Amendments to the Drawings:

The attached annotated sheets of drawings include changes to FIGS. 1, 2, and 12 and shows the changes to be made to the original sheets including FIGS. 1, 2, and 12.

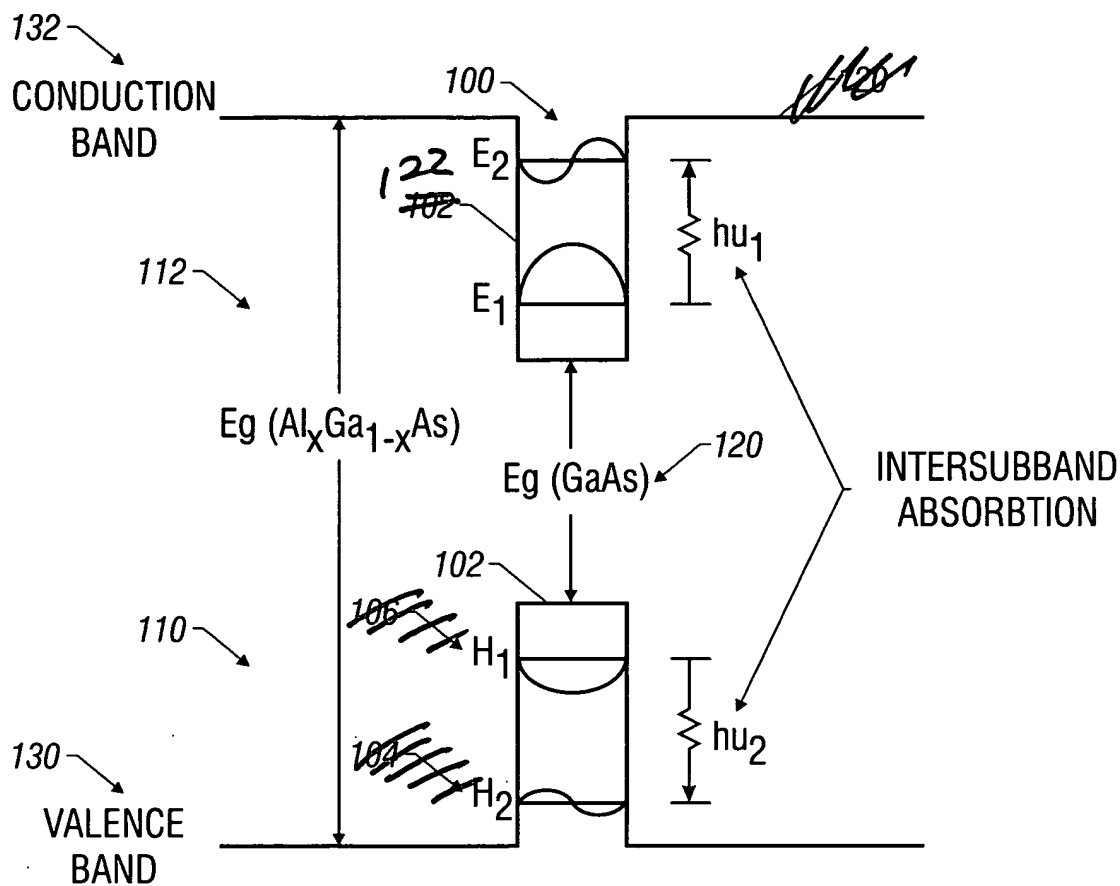
In FIG. 1, incorrect labels have been deleted or modified. In addition, "Prior Art" has been added per Examiner's requirement.

FIG. 2

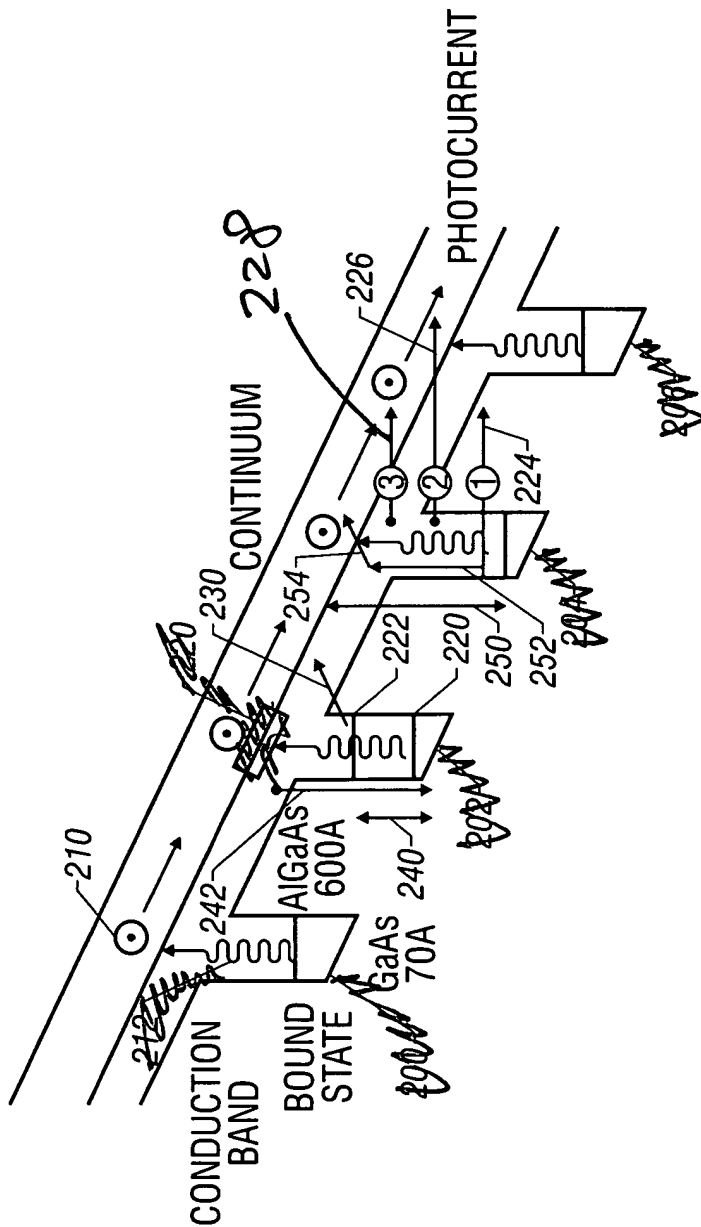
In FIG. 2, incorrect labels have been deleted. A label of "228" has been newly added to conform to the textual description. In addition, "Prior Art" has been added per Examiner's requirement.

FIG. 12

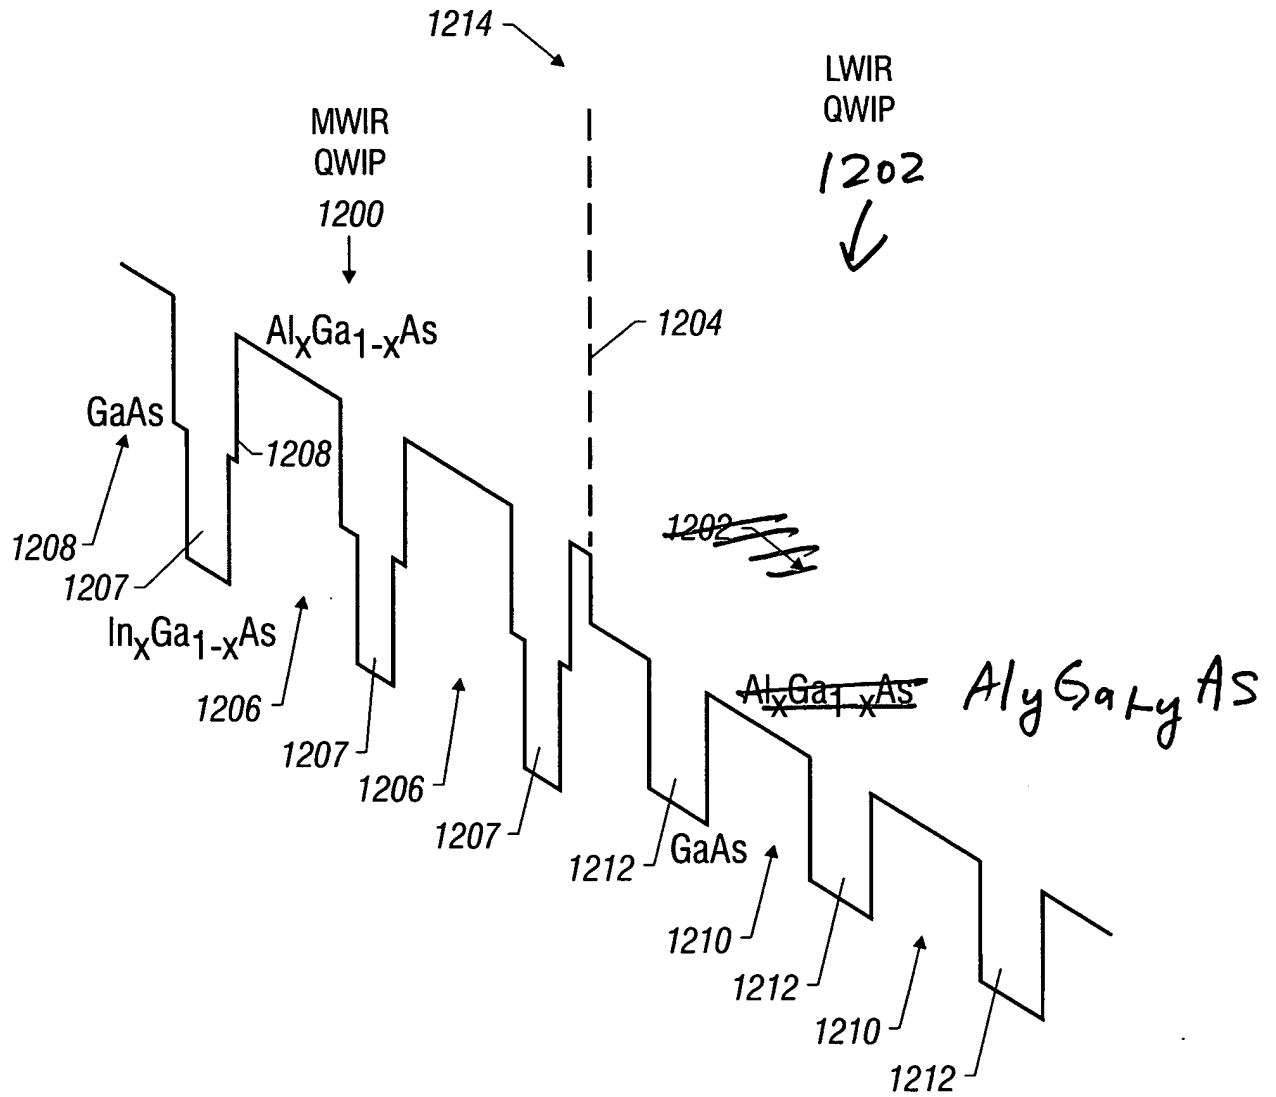
In FIG. 12, the position of label "1202" has been changed. In compliance with the examiner's suggestion and requirement, the composition label of the barrier layers for the LWIR QWIP 1202 has been modified to be different from that of the MWIR QWIP 1200.
